Project	IEEE 802.16 Broadband Wireless Access Working Group < http://ieee802.org/16 >	
Title	Idle handover & location update in 802.16e	
Date	2004-03-12	
Submitted		
Source(s)	Changhoi Koo, Jungje Son, Seungil Yoon, Hyongoo Kang, Geunhwi Lim Samsung Electronic, Suwon P.O.Box 105, 416, Maetan-3dong, Yeongtong-gu, Suwon-si, Gyeonggi- do, Korea 442-742	Mailto : chkoo@samsung.com jungje.son@samsung.com siyoon72@samsung.com hyongoo.kang@samsung.com geunhwi.lim@samsung.com
Re:	Call for inputs for commentary of p802.16e/D1	
Abstract	This contribution describes Enhanced Handover Mechanism for supporting Active BS Set in IEEE P802.16e/D1-2004.	
Purpose	Discuss and Adopt enhanced feature of p802.16e/D1	
Notice	This document has been prepared to assist IEEE 802.16. It is offered as a basis for discussion and is not binding on the contributing individual(s) or organization(s). The material in this document is subject to change in form and content after further study. The contributor(s) reserve(s) the right to add, amend or withdraw material contained herein.

Idle hand over & Location Update in 802.16e.

Changhoi Koo, Jungje Son, Seungil Yoon, Hyongoo Kang, Geunhwi Lim

Figure XX. Idle Handover Procedure

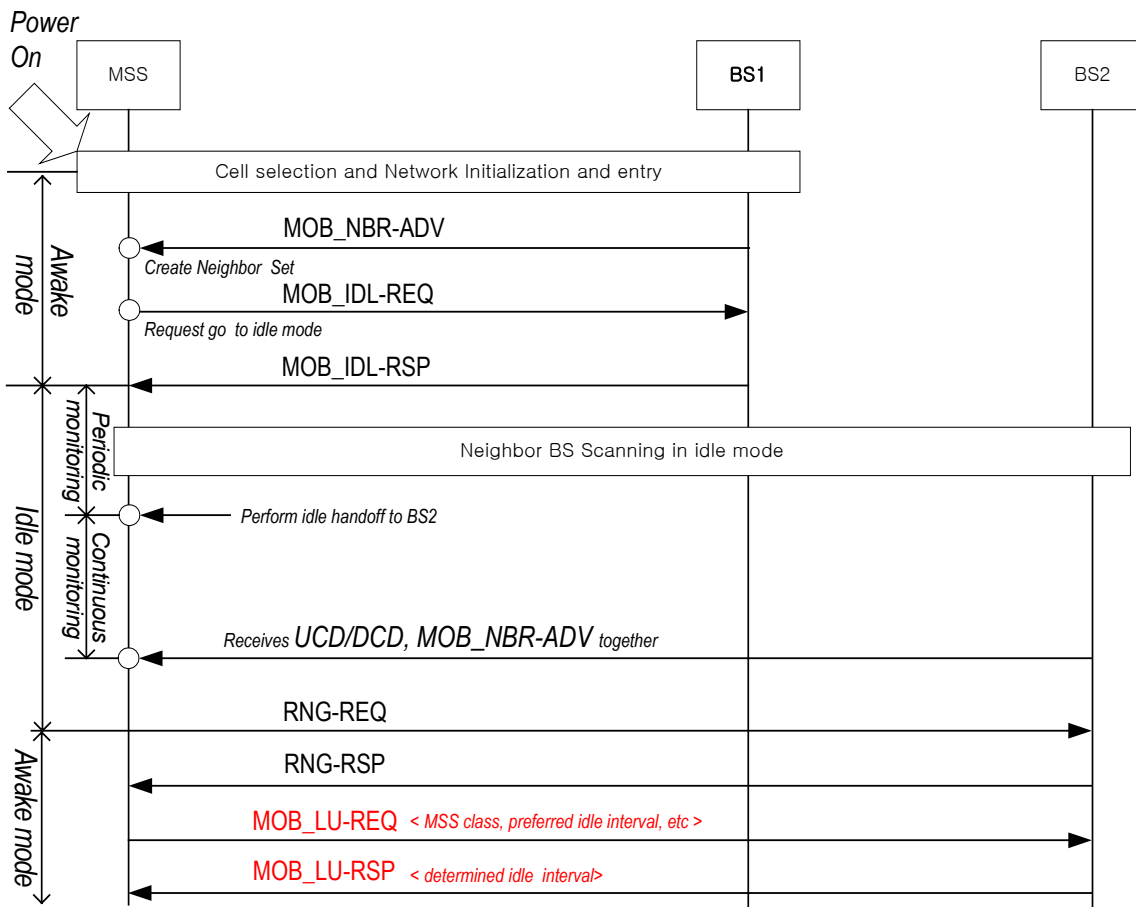
An idle handover is a handover in which the MSS moves to another BS from the serving BS. During idle mode, the MSS shall periodically scan the cell with the strongest signal and shall update the neighbor set information whenever it detects that the configuration change count of the MOB_NBR-ADV message has been changed. An MSS may perform an idle handover if such an action is necessary with respect to its PHY signal quality. While performing the idle handover, the MSS shall monitor all frames at least once in order to receive UCD, DCD, and MOB_NBR-ADV messages on the broadcast CID transmitted by the target BS and update handover related parameters in these messages. After receiving all these messages, the MSS shall resume the operation in idle mode and, if needed, the MSS performs the Location Registration using MOB_LU-REQ/RSP messages exchanging with BS.

The Figure shows the overview of performing the idle handover from BS1 to BS2.

If the BS does not support idle mode, the MSS shall perform the network re-entry and initialization procedures to transit its mode to Awake mode. During idle handover for a specified timer, **guard timer**, transmitted by the BS using MOB_NBR-ADV message, the MSS is prohibited performing successive idle handover. After a successful idle handover, the timer is reset.

Figure XX. Timer Based Location Update Procedure

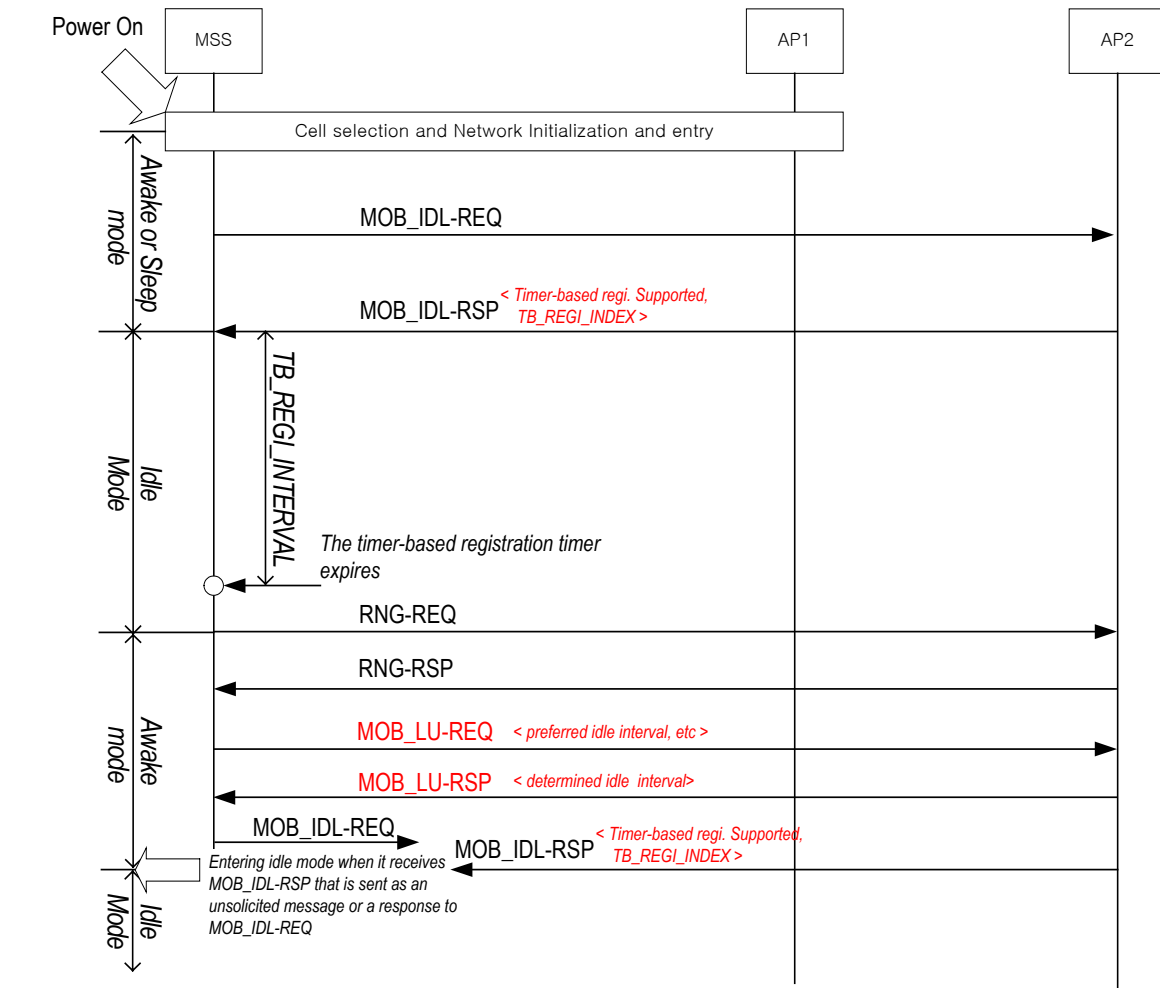
Upon entering idle mode, the BS can enable or disable the MSS to register the location when a specified timer expires. The BS shall inform the MSS of timer-based registration capability using the TB_REGI_REQUIRED field of the MOB_IDL-RSP message. The MSS shall restart this timer when re-entering idle mode if the timer-based registration is enabled. The timer-based registration causes the MSS to register at regular intervals based on TB_REGI_INTERVAL. If both the zone-based registration and the timer-based registration are enabled together, the MSS shall perform the zone-based registration. The MSS shall compute the timer expiration count as followings.

The TB_REGI_INTERVAL is an integral multiple of the REST_INTERVAL and so the MSS can increment the timer-based registration counter every specified multiple of REST_INTERVAL frames. The counter is reset when the timer is restarted.
